Proposal for Supplement 1 to the 02 Series of Amendments to the UN Regulation No. 134 (Hydrogen and Fuel Cell Vehicles)

Submitted by the Task Force amending UN Regulation No. 134**

Figure 2
Verification test for expected on-road performance (pneumatic)

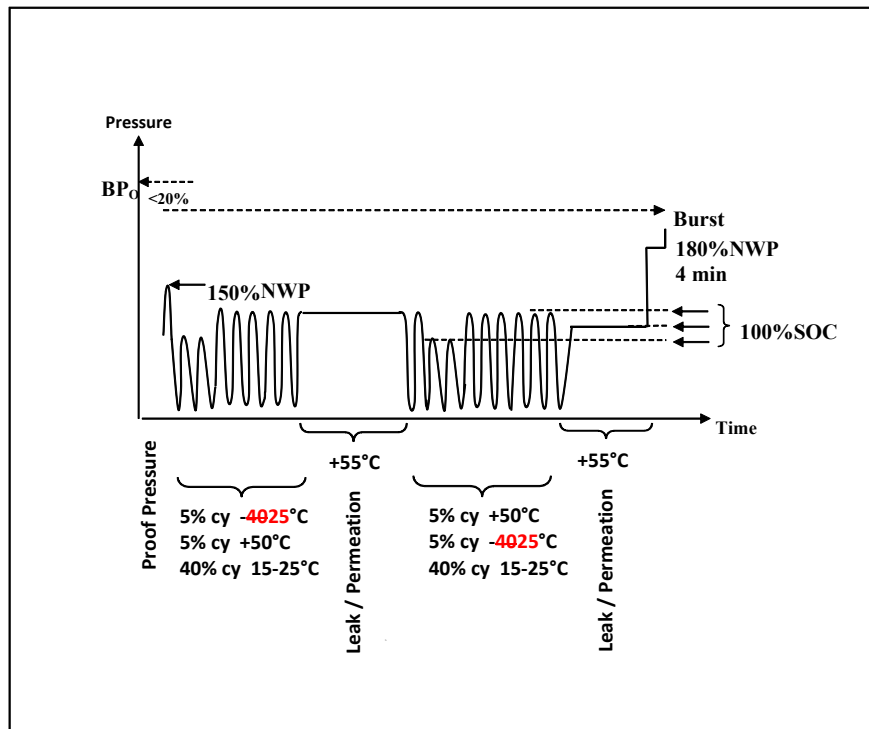
Paragraphs 5 Figure 2., amend to read:

In Figure 2 illustrating the sequence for the Verification test for expected on-road performance (pneumatic) the temperatures for the cold cycles need to be corrected due to a copy and paste error when transposing GTR 13 phase 2 into UN-R 134 series of amendments 2.

FLOW CHART AMENDMENT CONSIDERING CHAMBER MATERIAL AND GEOMETRY.

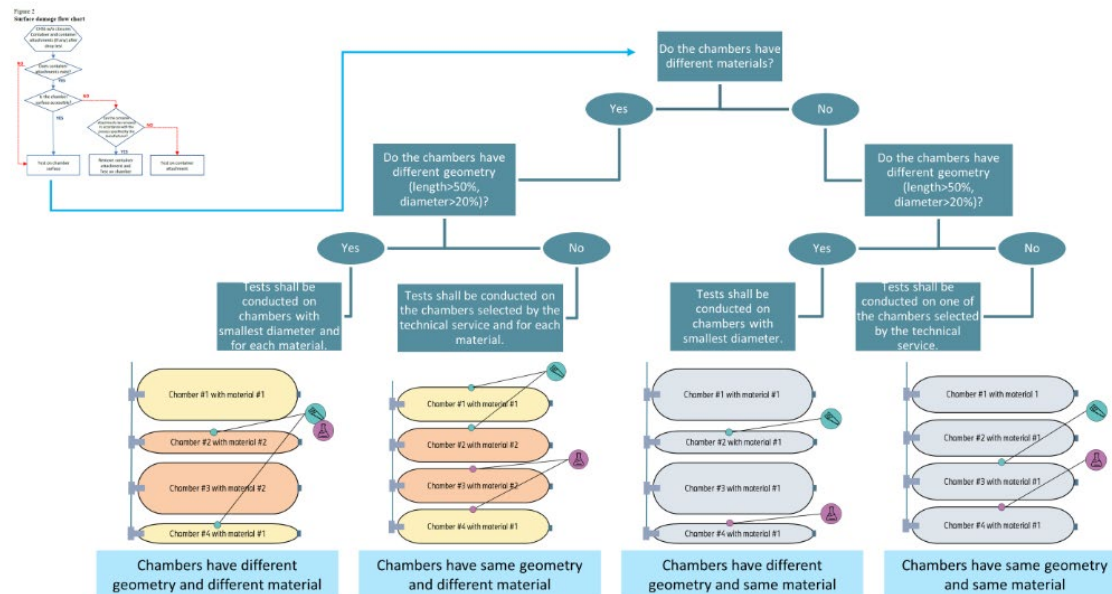
Multiple interconnected chambers: containers with multiple interconnected chambers are a more recent development for hydrogen storage systems. In case the development progresses to a design with more than one chamber design within the container, the technical services could find it necessary to test individual designs or use the worst-case approach. Therefore, phrases have been added to paragraphs 3.3. and 3.4. to address this need. It was agreed that slides shown during the TF meeting illustrating the worst-case approach for containers with multiple interconnected chambers should be included in the justification as guidance.

Guidance for worst-case approach:

- Container consists of several chambers.
- All chambers are designed for the same burst pressure.
- Container attachments are removable and chamber surfaces are accessible.

Material change	Affecting burst pressure performance	Affecting chemical exposure performance	Comment
Fiber material	Yes	Yes	Test shall be conducted for each material.
Resin material	Yes	Yes	Test shall be conducted for each material.
Fire proof protection	No	Yes	Test shall be conducted for each material.
Glass fiber protection	No	Yes	Test shall be conducted for each material.

Geometry change	Affecting burst pressure performance	Affecting chemical exposure performance	Comment
Length \leq 50%	Not significantly	No	Different geometry, but no significant influence on burst pressure \rightarrow no additional testing necessary.
Length $>$ 50%	Yes	No	Test shall be conducted for each geometry. See R134 table "change of design".
Diameter \leq 20%	Not significantly	No	Different geometry, but no significant influence on burst pressure \rightarrow no additional testing necessary.
Diameter $>$ 20%	Yes	No	Test shall be conducted for each geometry. See R134 table "change of design".
